**MUNICIPAL CORPORATION
KARACHI.**

Reference No. B. S. P. 866/40.

PLAN SHOWING THE PROPOSED BUILDING ON PLOT NO 79 O.T.4 OLD TOWN QUARTER
SCALE 8" TO 1" INCH.

With reference to your application dated 7th August 1940
with a plan for the proposed buildings/additions and alterations on plot
No. 79 Survey Sheet No. O.T.4, Old Town. Quarter,

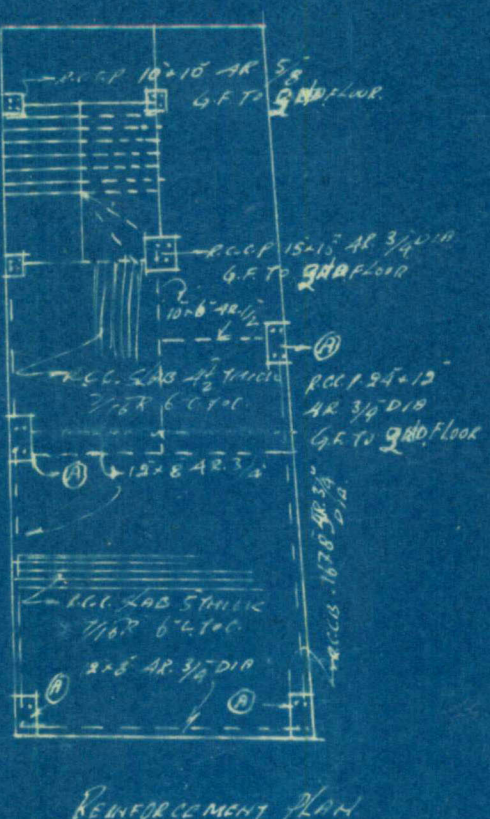
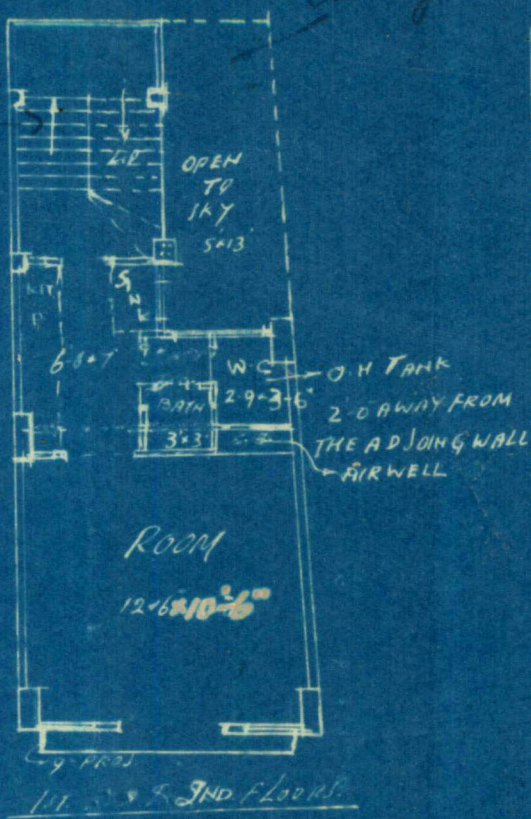
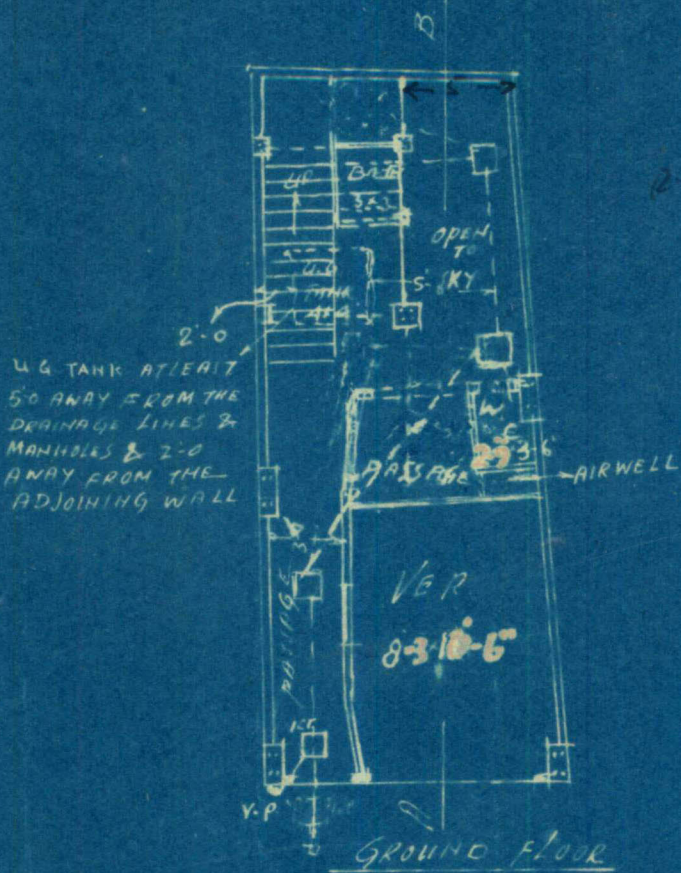
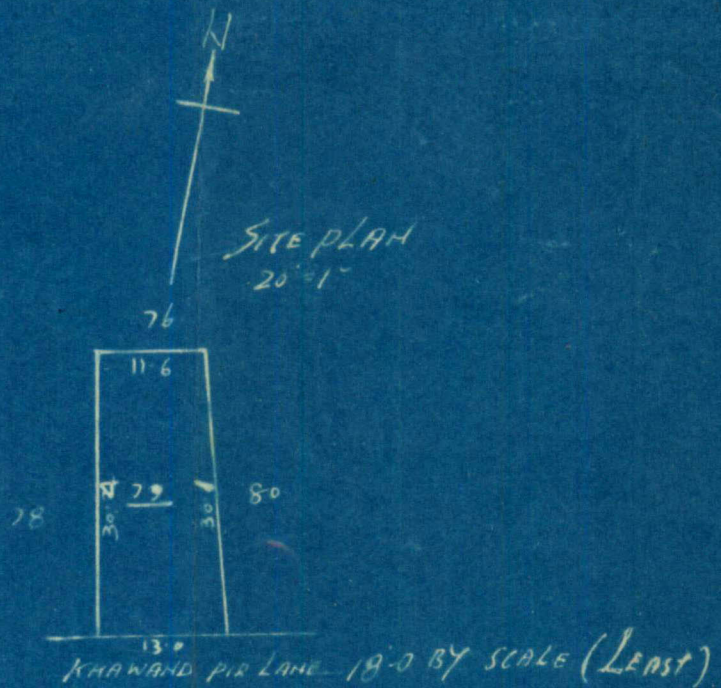
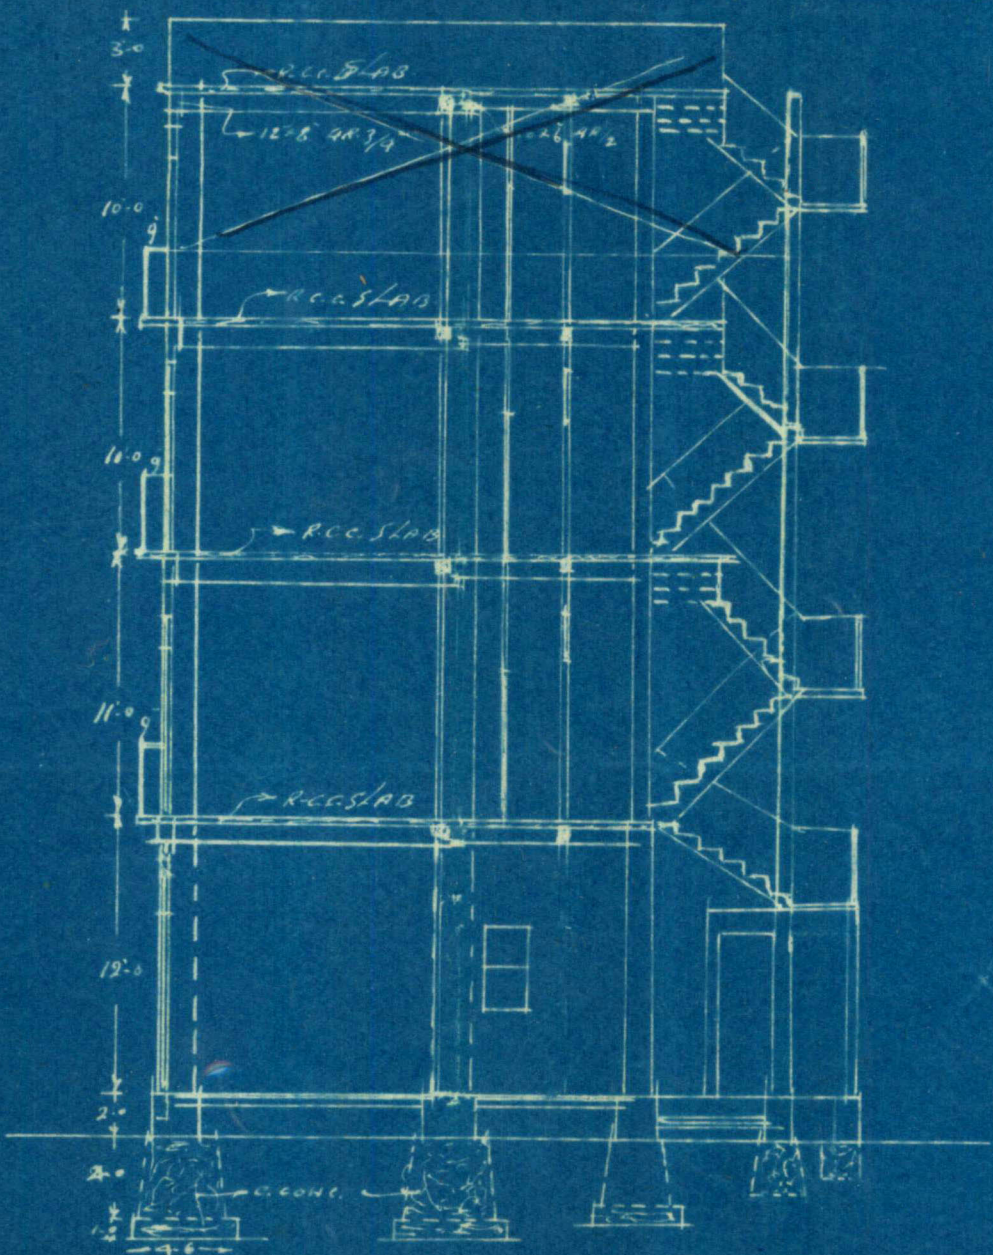
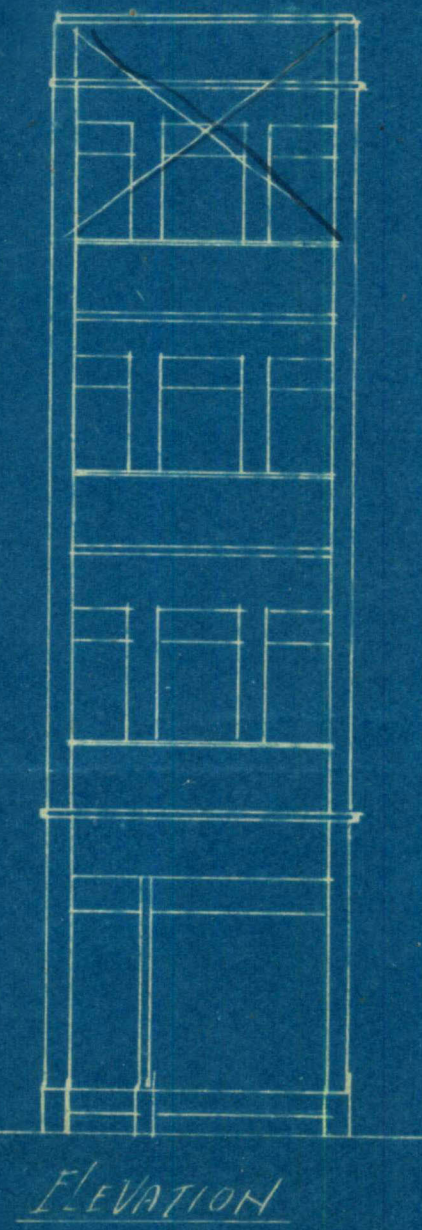
Please ask the architect to
send the plans with corrections
made by H.O, A.E + L.S. Dept.
so that clear plan may be
available for reviewing, as the
present copies are full of correction.

PLAN SHOWING THE PROPOSED BUILDING ON PLOT No 79 O.T.4 OLD TOWN QUARTER
SCALE 8" TO AN INCH.

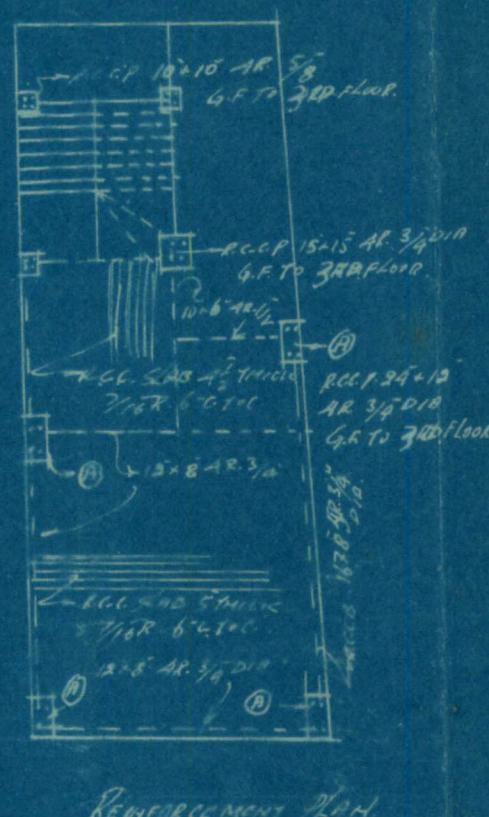
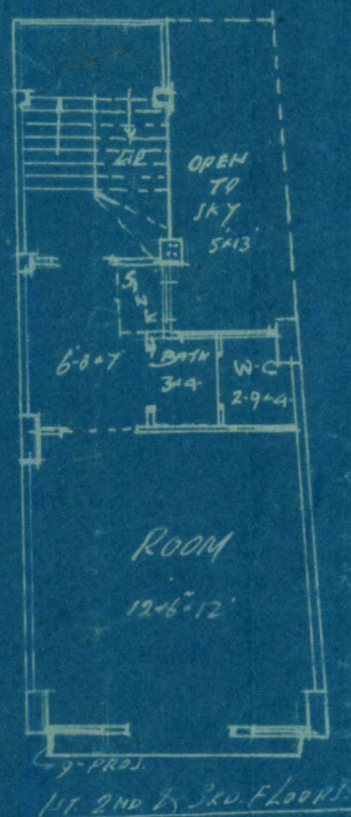
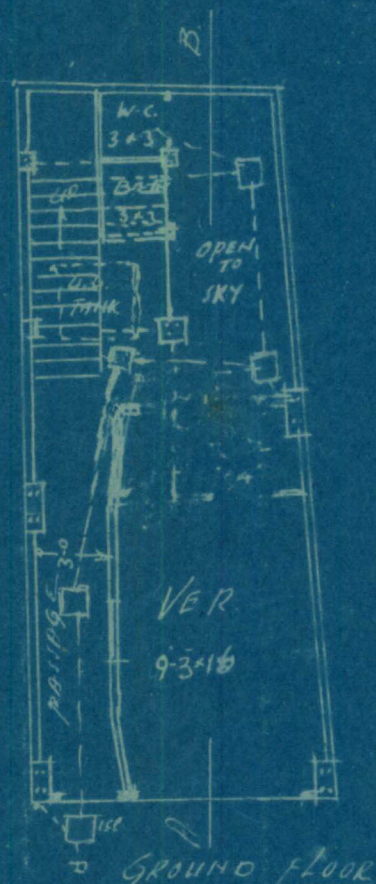
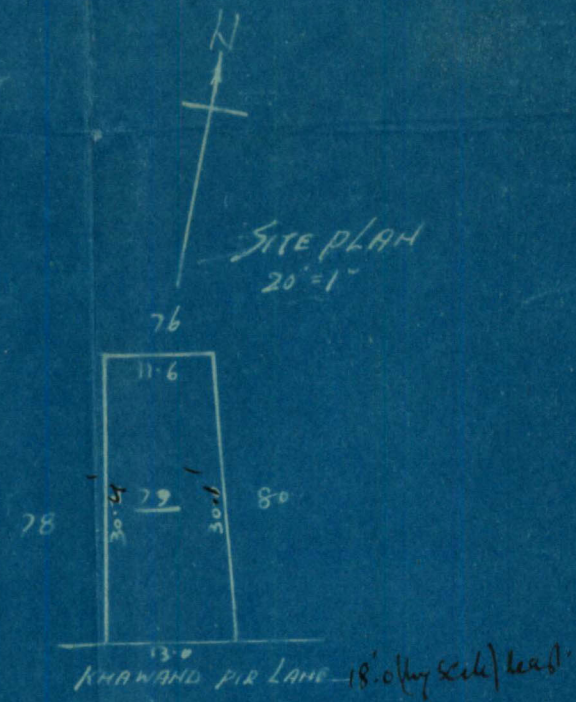
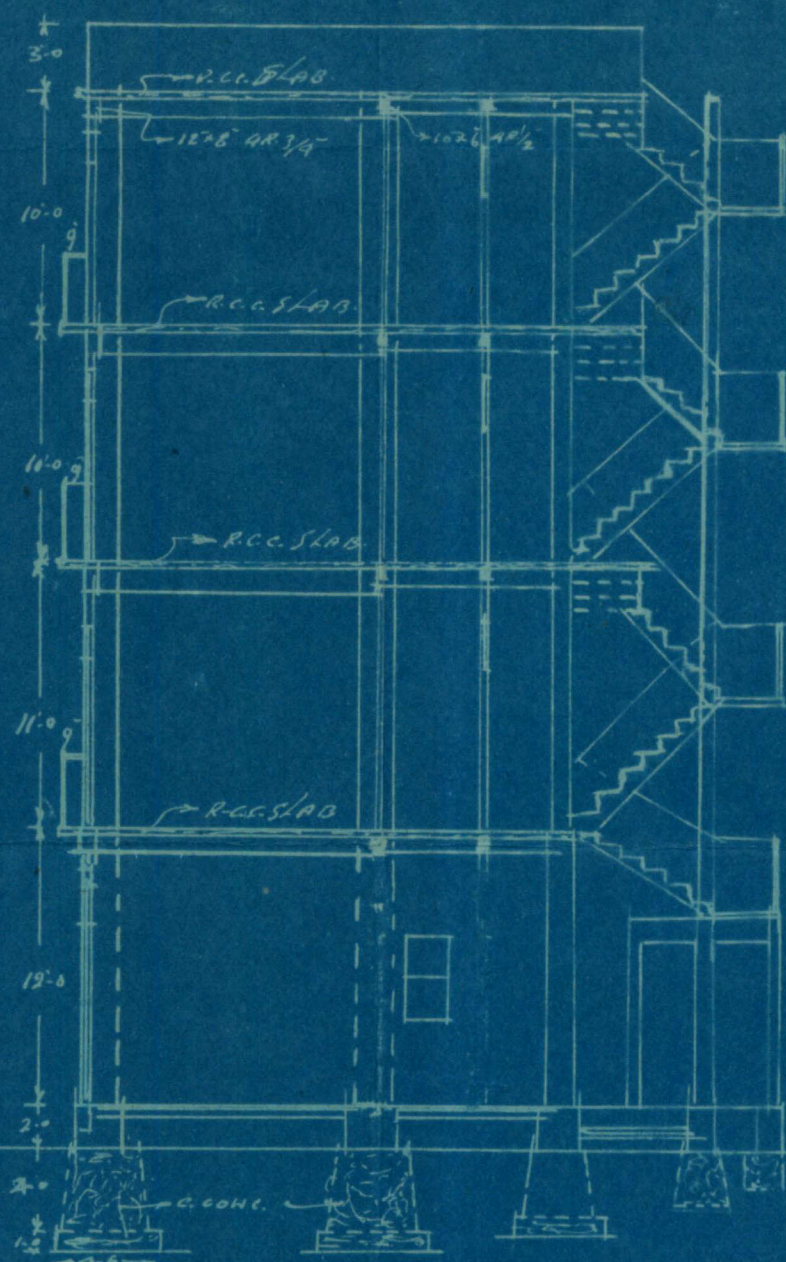
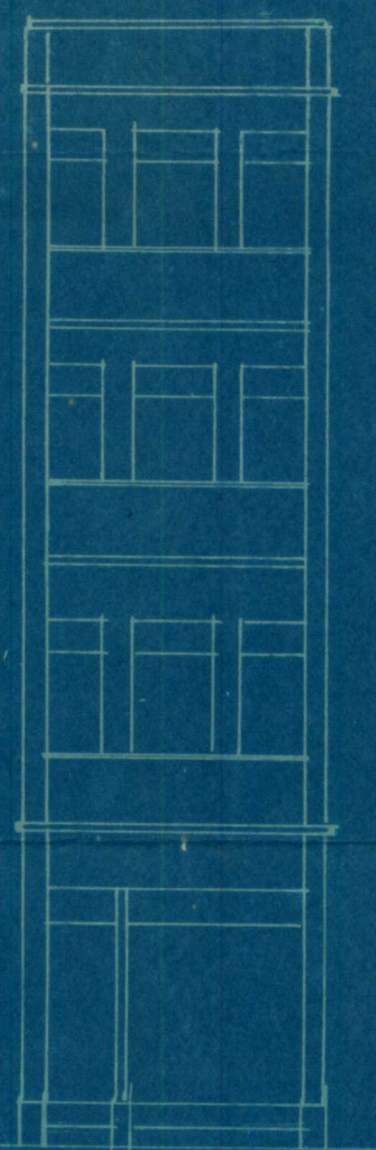
- ✓(1) H.O's objections. Ground floor: Back boundary of "Ver" not clear.
- ✓(2) No kitchens provided.
- ✓(3) Space behind the stairs - purpose not stated.
A.E's objections.
- ✓(4) W.C. adjoining living room is against rules.
- ✓(5) Better drawings may please be submitted as blue-print is not legible.
- ✓(6) Dimensions of the U.G. tank should be given and it should be at least 5' away from the manholes and drainage lines. Also it should be 2' away from adjoining owners' wall.
- ✓(7) O.H. tank should be shown.
- ✓(8) I.T. should be provided within the owners' limit and V.P. should be provided to it.

- ✓(11) Plans must be signed by the owners.
- ✓(12) W.C. behind staircase cannot be allowed, also one adjoining the room is against rules.
- ✓(13) Street width be given and height regulated accordingly.
- ✓(14) Passage will be too narrow, due to pillars etc.
- ✓(15) New drawings require to be submitted as the one's sent ~~are~~ cannot be read.

1. W.C. adjoining living room is against rules.
2. Better drawings may please be submitted as blue-print is not legible.
3. Dimensions of the U.G. tank should be given and it should be at least 5' away from the manholes & drainage lines. Also

4. O.H. tank should be shown.
5. I.T. ~~etc~~ should be provided within the owners limit and V.P. should be provided to it.

Ground floor: Back boundary of
"Ver" not clear.

no Kitchens provided.

Space behind the stairs -
purpose not stated.

- 1 & 2. Complied with. The Kitchen platform is provided.
3. There are Bath & W.C. proposed below the staircase. Since the staircase is to be of R.C.C., I hope there will be no objection to the same.

4. The W.C. has been shifted.
- 5 to 8 Complied with.

- 9 & 10. Complied with.

11. The plans have been signed as also the "A" Form.
12. As the staircase is of R.C.C. there should be no objection to the W.C. below the staircase. However the papers may kindly be sent to the Chief Officer for his usual approval.
13. Complied with.
14. The passage has been increased.
15. Complied with.
